CITY OF PORTLAND, MAINE

Project Name: **Master Development Plan for Senior Housing (lots 3 and 4)**
Project ID: #2016-033
Address: 605 Stevens Avenue CBL: 136 E006001
Applicant: Sea Coast at Baxter Woods Associates, LLC
Planner: Jean Fraser

PLANNING BOARD REPORT PORTLAND, MAINE

605 Stevens Avenue Senior Housing (Lots 3 and 4)
Master Development Plan

Perspectives (see Exhibit B)

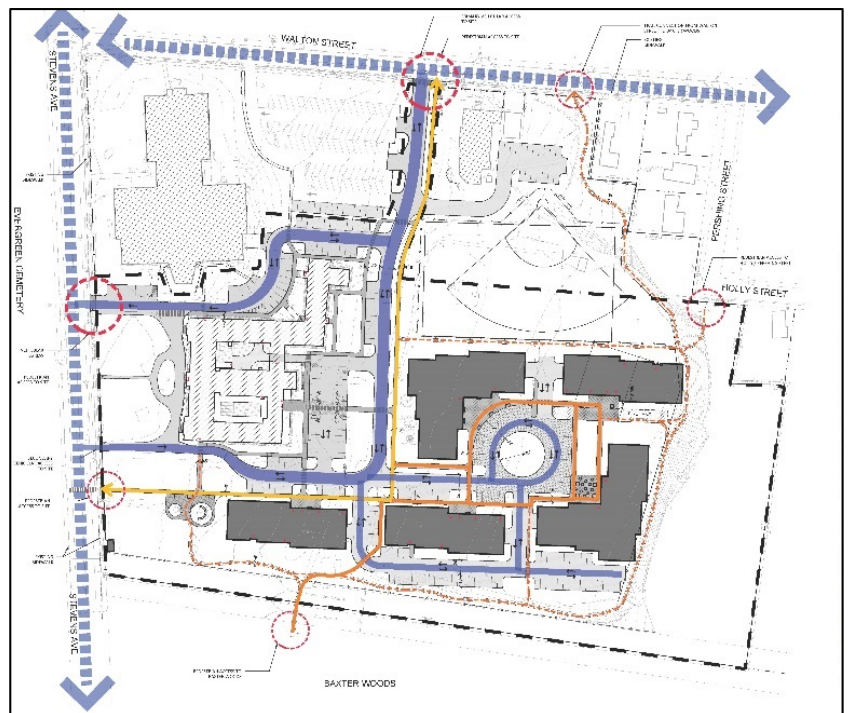
- The design of the buildings has been revised to incorporate flat roofs and more neutral colors as shown in the submitted (as part of the final submission) rendering at right, as located in the vicinity of the "Meadows" part of Baxter Woods (see discussion below regarding overall design issues).

Baxter Woods (Exhibit B Arch Info) that gives an impression of how the new buildings would appear from that location. The perspectives are of the former design, with gables and extracted below:

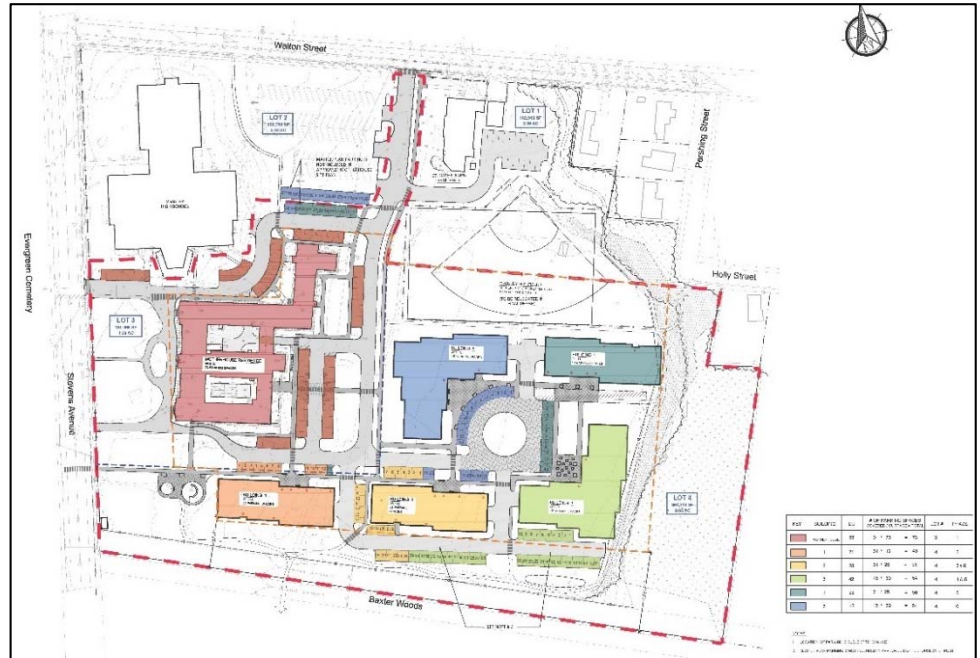
The Parking Diagram (Plan P10) shows a total of 395 parking spaces, of which 212 spaces are on the surface and 183 are beneath the buildings. The allocation of the surface parking is shown as color-coded on the Parking Diagram:

Some of the parking for the final build out is located between the new buildings and Baxter Woods and this was raised as a concern by many members of the public and some members of the Planning Board. In view of the fact that that monitoring of the parking demand may show that some of this parking is not required to meet future demand, staff requested (Attachment 5) that the applicant reconsider the way the parking was allocated during all but the last phases to avoid constructing the parking between the buildings and Baxter Woods until shown to be needed.

The revised phasing plan (Plan P7) has moved in that direction with less parking constructed in this location than in the earlier phases, but staff suggest that there should not be any parking in this location as described in the suggested condition of approval:

That the proposed parking may be reduced from the zoning requirement of 2 parking spaces per unit of new development (excludes the Motherhouse) if the parking monitoring studies show that the demand is less than 2 spaces per unit. No parking between the new buildings and Baxter Woods shall be constructed until after the fourth building is occupied, and only if the monitoring studies show that additional parking is necessary to meet demand. The phasing plan shall be revised to show all parking for phases II to V to be located to the north of the buildings southmost wall;
